Notice of Modification

Section 75W of the *Environmental Planning and Assessment Act 1979*

The project approval (05_0021) for the Wilpinjong Coal Project, granted by the Minister for Planning on 1 February 2006.

APPENDIX 7
FIGURE 1 – REGIONAL RECEIVER LOCATION PLANS

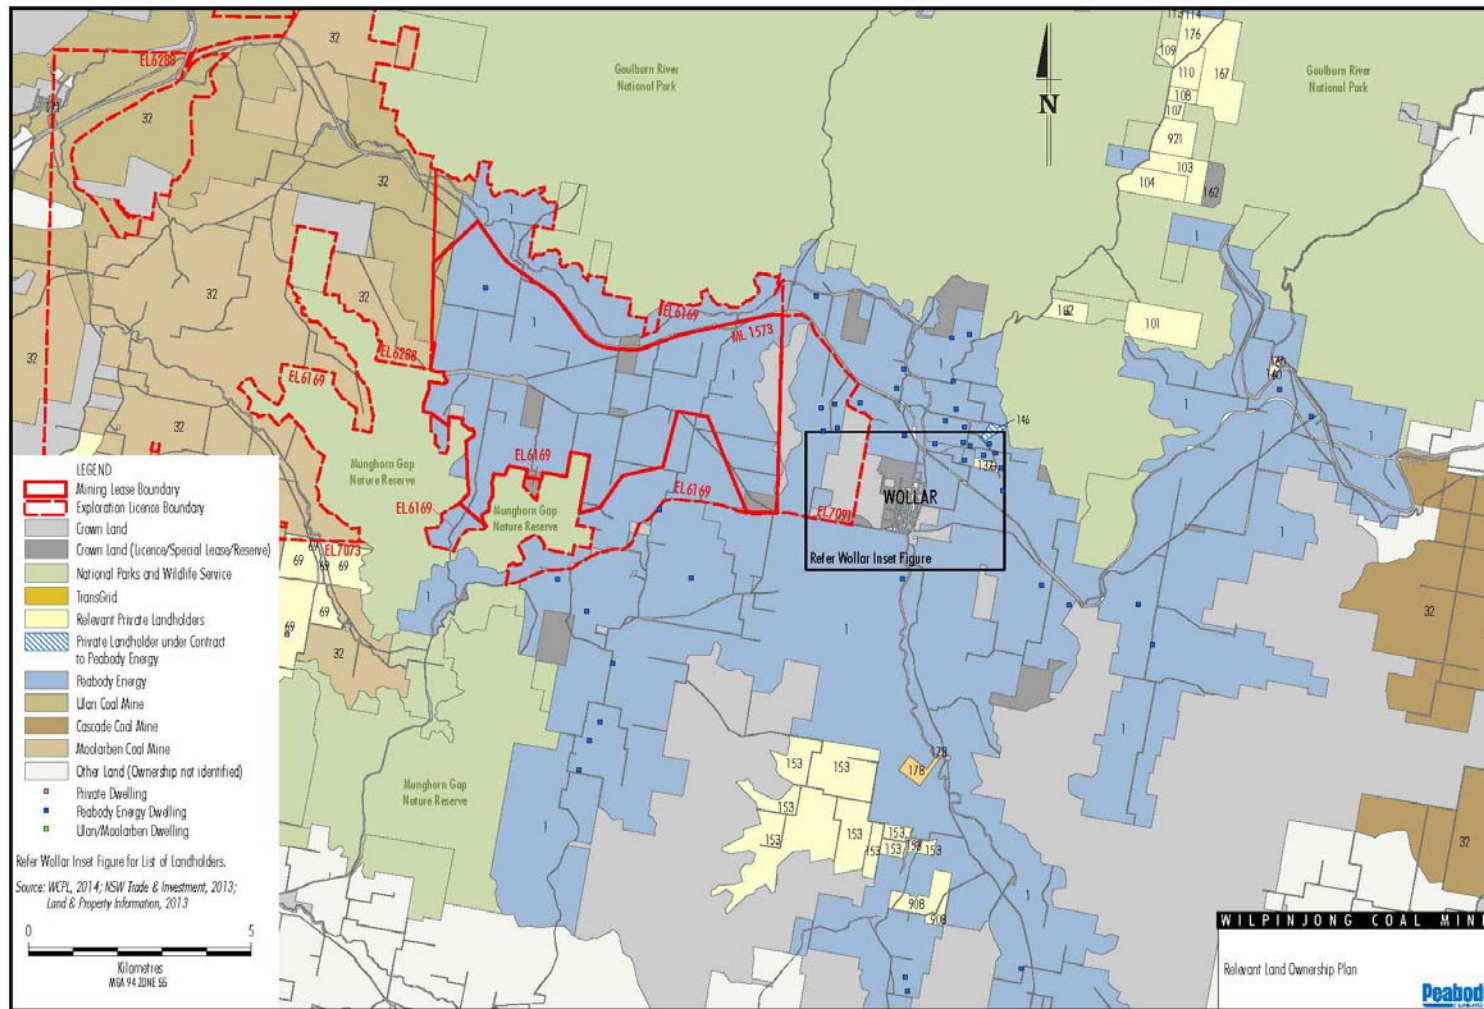
- 8) Delete Appendix 7, and insert the following:
